## Customer Notification

# V850E/Dx3 - DJ3/DL3

## 32-Bit Single-Chip Microcontrollers

### Operating Precautions

Figure: Additional Measures in case AFCAN clock is active when waking up

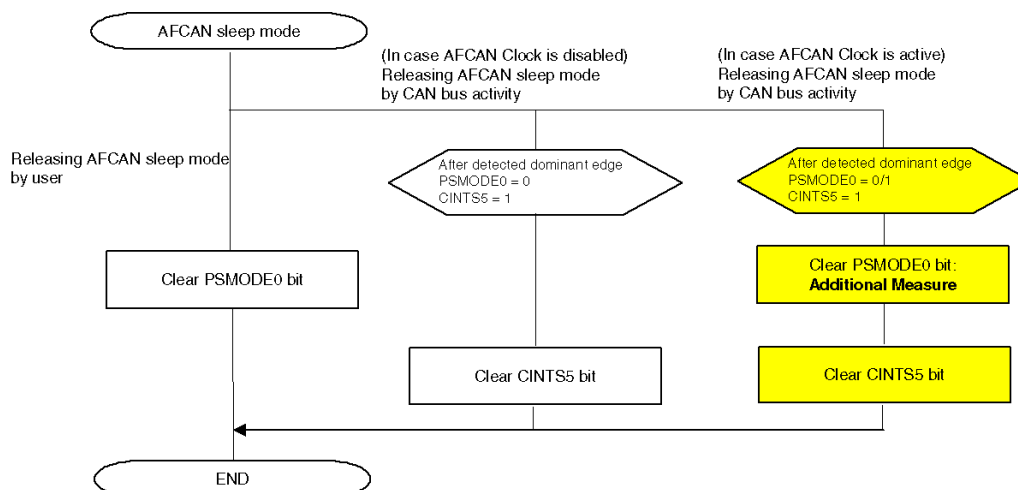
No. 7	AFCAN: Sleep Mode Wakeup (Specification change notice)
	<p><u>1. Description</u></p> <p>When the AFCAN macro is set into SLEEP mode, it can be waken up by CAN bus activity. This waking up is asynchronous to the operation of the macro and the CPU. By configuration setting, a WAKEUP interrupt can be generated by the AFCAN macro on the wakeup event. While the interrupt is generated asynchronously, the AFCAN macro may need another dominant edge on the CAN bus, or software clearing of the SLEEP mode, in order to restart its synchronous operation.</p> <p>During the time, after the interrupt already has been indicated, and before the CAN macro has restarted its synchronous operation, the registers of the AFCAN macro will not operate, because the AFCAN macro still remains in SLEEP mode. This time we will refer to as “wakeup dead time” in the following context.</p> <p>To resolve from the <i>wakeup dead time</i>, software and/or hardware measures are required.</p> <p><u>2. Exclusions</u></p> <p>This Operating Precaution is <b>only applicable</b> to applications, which are fulfilling at least one of the following three conditions:</p> <ul style="list-style-type: none"> <li>• SLEEP Mode of AFCAN is used <b>and</b> the possibility to wake up AFCAN by CAN-Bus events is given (see remark 1 below).</li> <li>• During SLEEP mode of the AFCAN macro, a CAN-Bus wakeup condition occurs, while the AFCAN macro is supplied with clock (see remark 2 below) <b>and</b> <ul style="list-style-type: none"> <li>- after waking up from SLEEP mode of the AFCAN macro, the application software does <b>not</b> wait until the SLEEP mode is released by polling the CnCTRL (PSMODE) register, before continuing operation with the AFCAN macro (see remark 3 below) <b>and</b></li> <li>- the CPU can reach instructions, where AFCAN registers are accessed while the AFCAN macro is still in SLEEP mode, due to the missing waiting condition.</li> </ul> </li> <li>• During SLEEP mode of the AFCAN macro, a CAN-Bus wakeup condition occurs, while the AFCAN macro is supplied with clock (see remark 2 below) <b>and</b> <ul style="list-style-type: none"> <li>- after waking up from SLEEP mode of the AFCAN macro, the CAN Bus Transceiver generates a <b>long-lasting or permanent dominant level</b> to the CRXD input of the AFCAN macro, instead of the propagated CAN-Bus level.</li> </ul> </li> </ul> <p><b>Remarks:</b></p> <ol style="list-style-type: none"> <li>1. If the CAN-Bus Transceiver does not propagate the CAN-Bus signal, while the AFCAN macro is in SLEEP mode, and also does not forward a wakeup signal to CRXD, <b>this Operating Precaution is not applicable.</b></li> <li>2. The clock supply to the AFCAN macro can be stopped, depending on the features of the device, and the system design of the application. If the clock supply to the AFCAN macro is stopped, while a wakeup condition occurs, <b>this Operating Precaution is not applicable.</b></li> <li>3. The maximum waiting time for this loop can be up to 10 bits of the CAN-Bus Baudrate. Waiting while retrying to clear CnINTS (Bit 5) can be used alternatively.</li> </ol> <p><b>All other applications are not affected by this Operating Precaution.</b></p>

The following flowchart illustrates, how and whether additional measures have to be taken in software, to avoid the *wakeup dead time*.

Within the WAKEUP interrupt routine, before accessing any other register or area of AFCAN, the SLEEP mode can be canceled by software, followed by a clearance of the WAKEUP interrupt flag.

```
<CnCTRL_PSMODE> = 0;    /* Clear SLEEP Mode */
<CnINTS_CINTS5> = 1;     /* Clear INTS5    */
...
/* following other parts of interrupt routine */
...
```
